addendum

No.	01	**Project:**	WCFPD Station 1
Date:	September 16, 2025	**Project No:**	025-2125

Modifications to Construction Drawings:

1 S300A **SHEAR WALL PLAN**
SCALE: ⅛" = 1'-0"

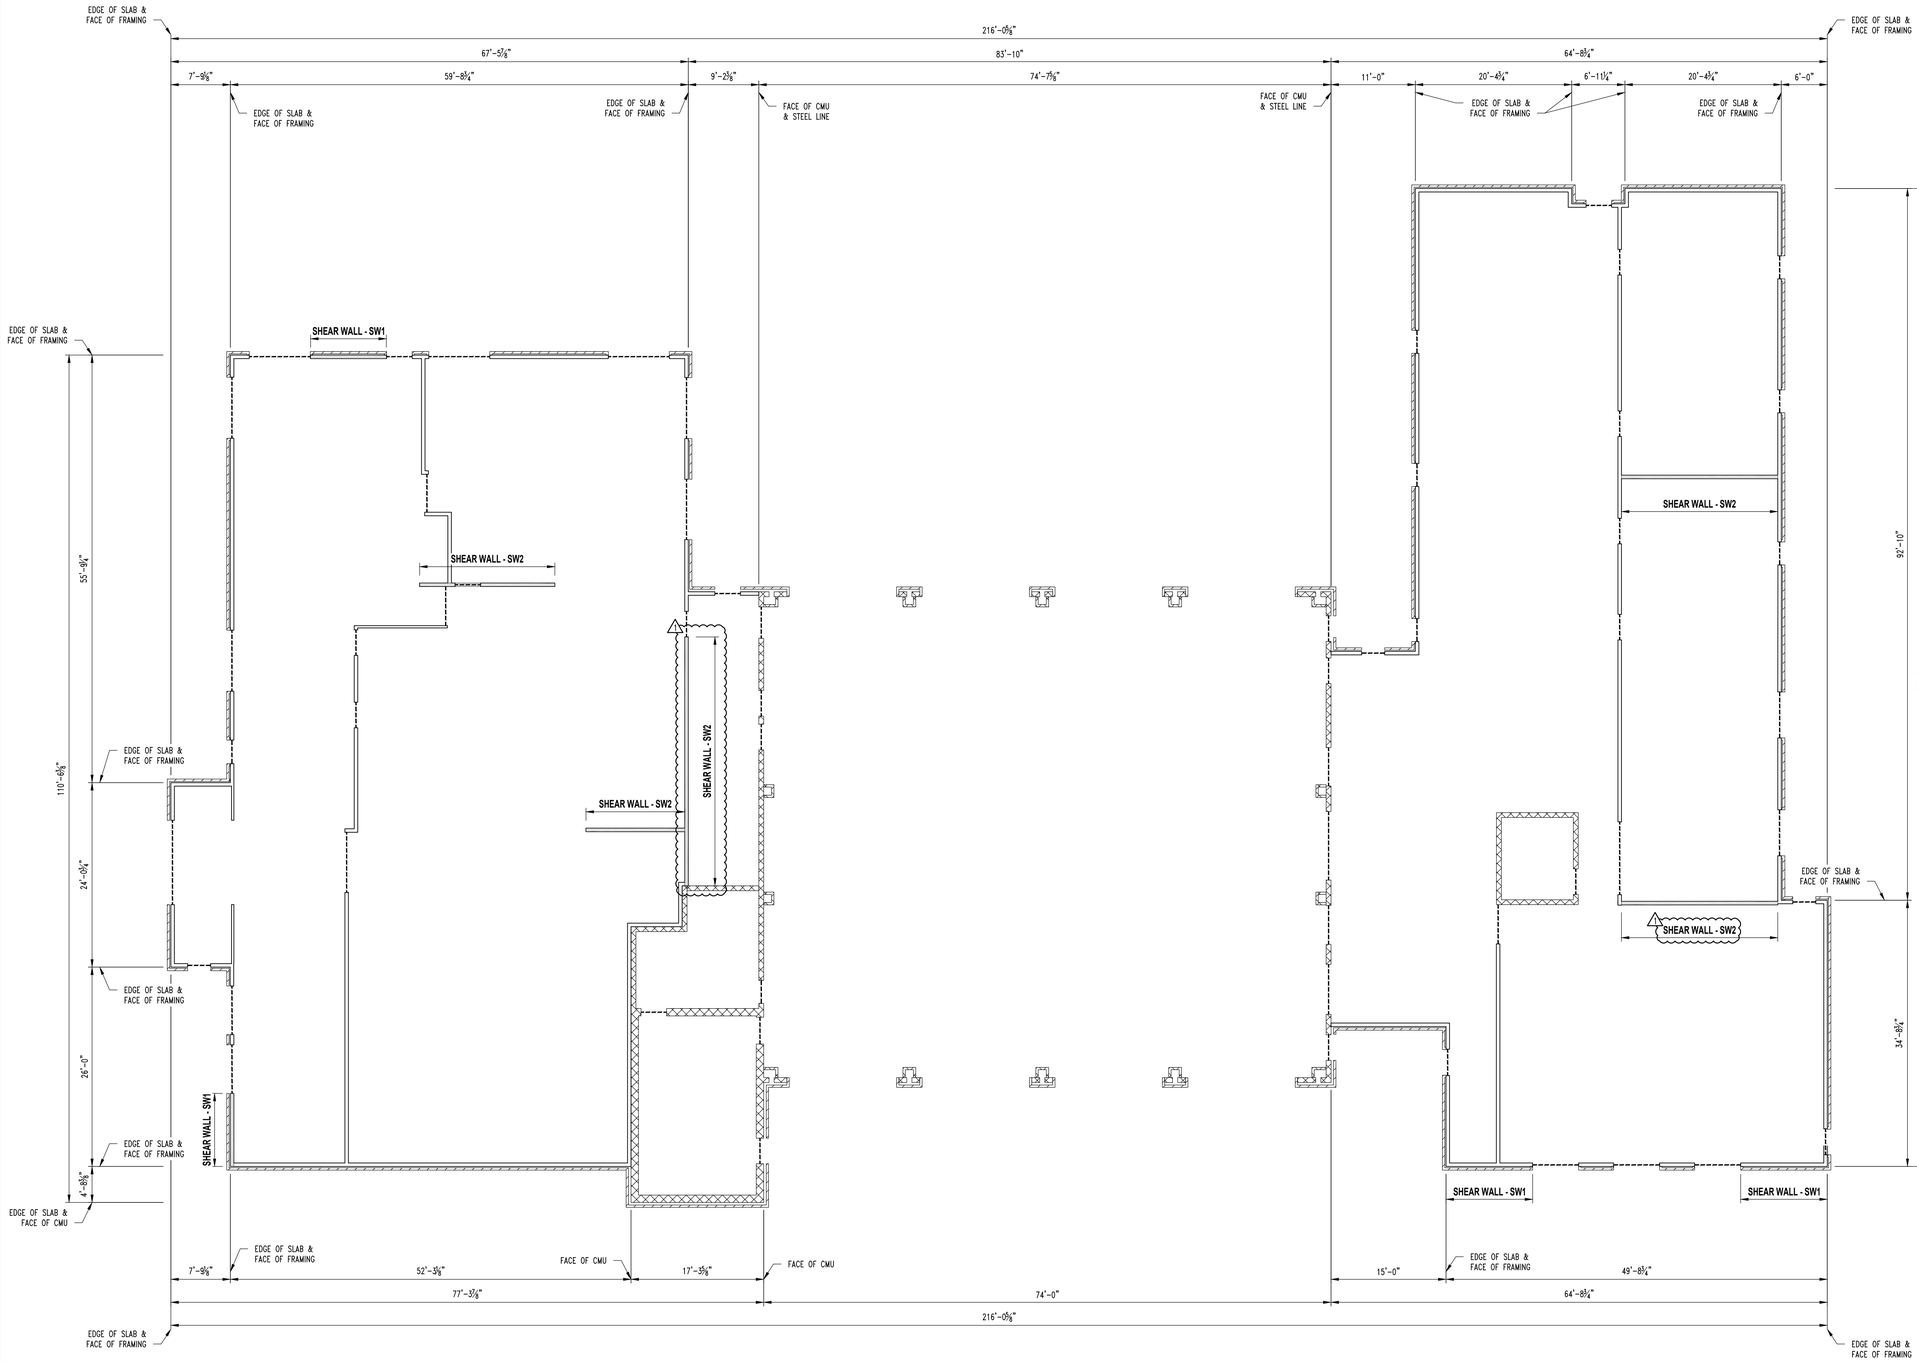
32) Sheet S300 – ROOF FRAMING PLAN
    a. ADD multiple headers.
    b. ADD Section S11A.
33) Sheet S300A – SHEAR WALL PLAN
    a. REVISE shear wall information.

S11A / S300 **ROOF FRAMING SECTION**
SCALE: 1½" = 1'-0"

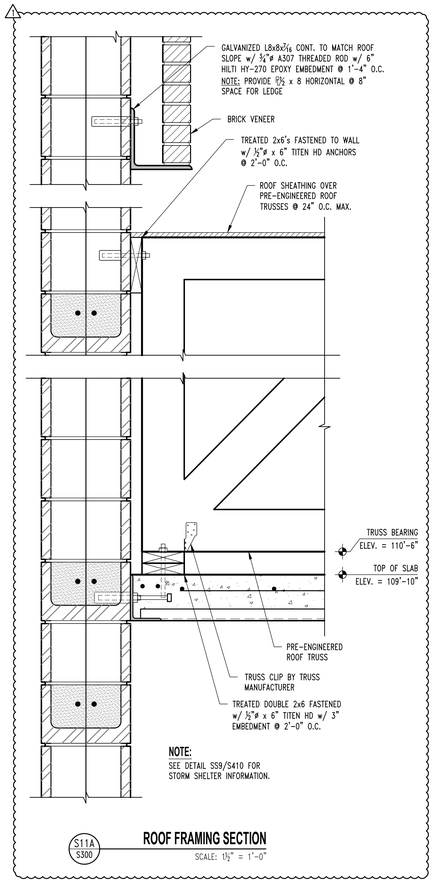
34) Sheet S310 – ROOF FRAMING DETAILS
    a. REVISE Details S4 and S5.
35) Sheet S311 – ROOF FRAMING DETAILS
    a. ADD Detail S11A.
    b. REVISE Detail S13.
